Ref: SCOP-0031 - Buchan Offshore Windfarm Limited – Buchan Offshore Wind – Scotwind NE8 Site

The scoping report submitted has been examined from an aerodrome safeguarding perspective and we would make the following observations:

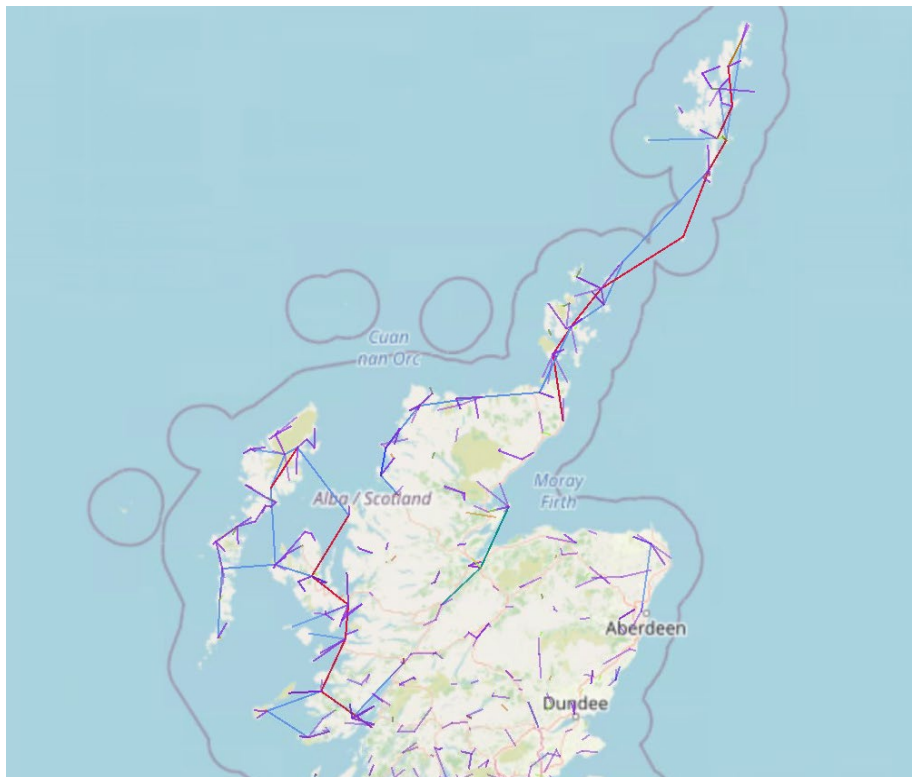
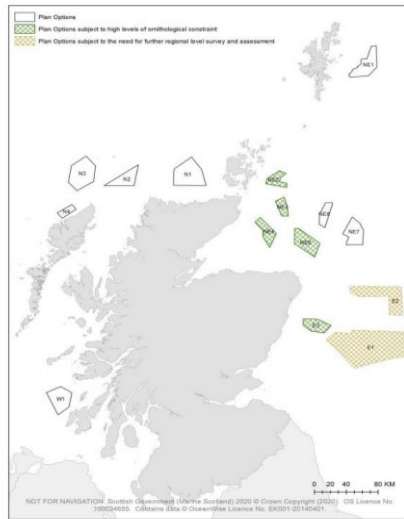
The conclusion is that the locations provided in figure 1.2 below should not cause interference to BT's current and presently planned radio network. For reference regarding the second picture below, the third shows where there are active/planned BT radio links shown with red, blue and purple lines.

BT requires 100m minimum clearance from any structure to the radio link path. If the proposed locations change, please let us know and we can reassess this for you.
